SUBJECT: CRYSTAL RIVER UNIT 3 - ISSUANCE OF AMENDMENT RE: ADMINISTRATIVE
CONTROLS AND SECURITY, EMERGENCY AND FIRE PROTECTION PLANS
(TAC NO. 49440)

AMENDMENT NO. 111 TO FACILITY OPERATING LICENSE NO. DPR-72-CRYSTAL RIVER UNIT 3

SAFETY EVALUATION BY THE OFFICE OF NUCLEAR REACTOR REGULATION
SUPPORTING AMENDMENT NO. 111 TO FACILITY OPERATING LICENSE NO. DPR-72
FLORIDA POWER CORPORATION, ET AL.
CRYSTAL RIVER UNIT NO. 3 NUCLEAR GENERATING PLANT
DOCKET NO. 50-302

FIGURE 6.2-1
CORPORATE ORGANIZATION

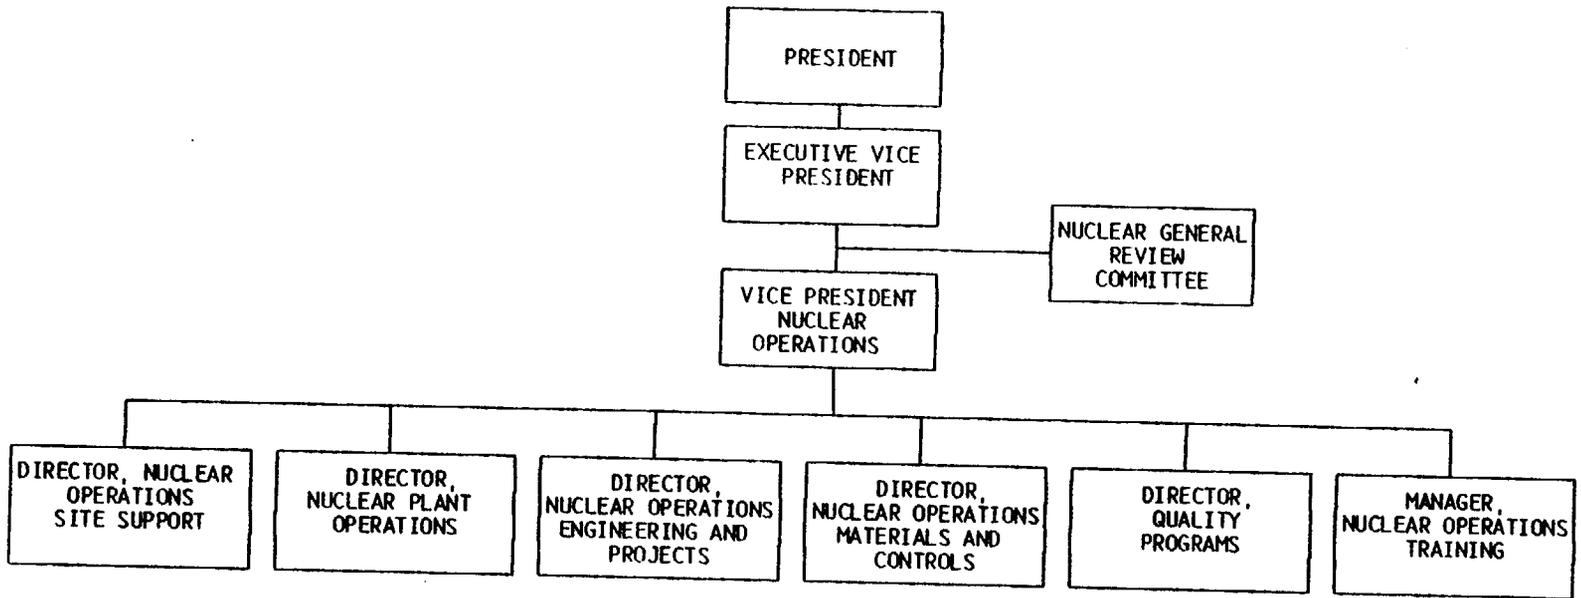
FPC proposed changes to Figure 6.2-1, "Corporate Organization," to indicate the present corporate organizational structure and to add a footnote stating that the corporate organization may be changed "without prior License Amendment provided that a revision to Figure 6.2-1 is included with the next License Amendment request."

Except for the footnote, the proposed change is administrative in nature, and is acceptable. The proposed footnote is not acceptable, even though the NRC staff does not disagree with its intent.

The staff recognizes the addition of the footnote as an attempt by the licensee to address the problem of burdensome administrative effort and delays in implementation of desired organizational changes. However, the proposed footnote would permit unilateral licensee changes to the TS without prior NRC review and approval. This would violate the regulations. A more appropriate solution is presented in Generic Letter 88-06, which permits removal of organization charts from the TS with appropriate changes to the administrative control requirements of the TS. In FPC letter dated April 27, 1989, it was stated that FPC will proceed expeditiously to request an amendment removing the organization charts in accordance with Generic Letter 88-06. This will satisfactorily accomplish the intended goal of the proposed footnote.

It is further noted that the requested footnote to Figures 6.2-1 and 6.2-2 has not been approved, as discussed in the Safety Evaluation. As you know, the NRC staff has recently addressed (Generic Letter (GL) 88-06) the need for a license amendment prior to implementing a change in organizational structure. That Generic Letter permits removal of organizational charts from the TS, with appropriate changes to the administrative control requirements of the TS. In your letter dated April 27, 1989, you stated that you will proceed expeditiously to request an amendment removing the organization charts in accordance with GL 88-06. A copy of the Safety Evaluation is also enclosed. The Notice of Issuance will be included in the Commission's biweekly Federal Register notice.

One of the requested changes to Section 6, Administrative Controls, involved the addition of a footnote to Figure 6.2-1, "Corporate Organization," and Figure 6.2-2, "Facility Organization," which would have stated that the organizations may be changed "without prior License Amendment provided that a revision to Figure 6.2-1 [and Figure 6.2-2] is included with the next License Amendment request." The staff determined that the proposed footnote was not acceptable, even though the staff does not disagree with its intent. The staff recognizes

FIGURE 6.2-2 - FACILITY ORGANIZATION

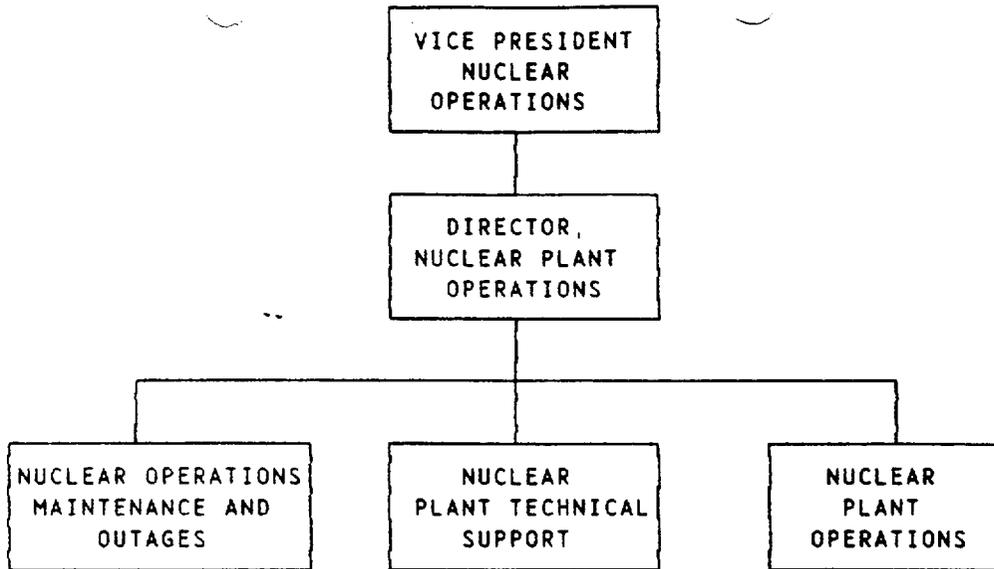
FPC proposed changes to Figure 6.2-2, "Facility Organization," to show the general responsibilities of each department rather than every position in each department and to add a footnote similar to that added to Figure 6.2-1.

Except for the footnote, the proposed changes are administrative in nature. Listing departmental responsibilities rather than the positions within each department will help clarify the responsibilities of each group and the inter-departmental relationships. The proposed changes are acceptable, except for the footnote, as discussed in Present Corporate Organizational Structure, above.
